TECHNICAL SERVICE BULLETIN, VIN: «VIN»
SB-75 Removing 30A Fuse, Go Power! Solar panel system.

Technical Service Bulletin SB-75 Repair Instructions

Purpose: To provide instructions on how to remove the 30-amp fuse from the solar panel docking port on the Go Power Solar panels system.

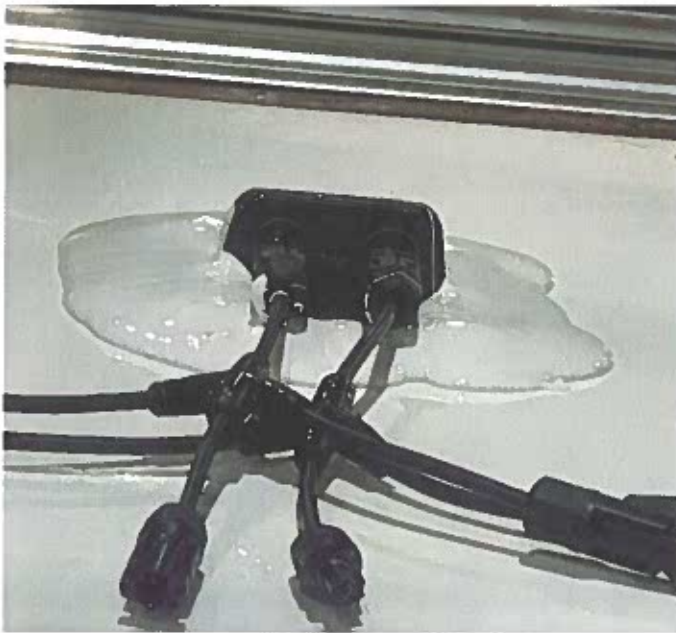
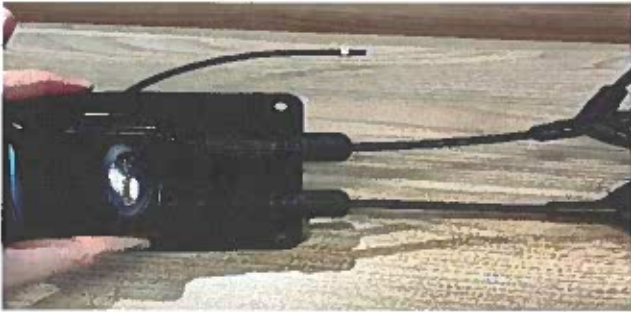
1. Cover the solar panel faces completely with drop cloths (or similar opaque material) to halt the production of electricity while working with the solar panel system.
2. Locate the solar panel docking port on the roof of the motorhome. There will be one (1) docking port per three (3) solar panels.

3. Locate the tabs on the side of the fuse. Push in tabs on the side of the fuse to remove the fuse from the port and then from the jumper.
4. Once the fuse is removed from port and jumper, inspect the connections for any sign of heat damage. If damage is found, please contact Tiffin Motorhomes for replacement parts at 256-356-0261 or by email service@tiffinmotorhomes.com.
5. If there is no heat damage present, install the jumper back into the docking port. Discard the fuse.
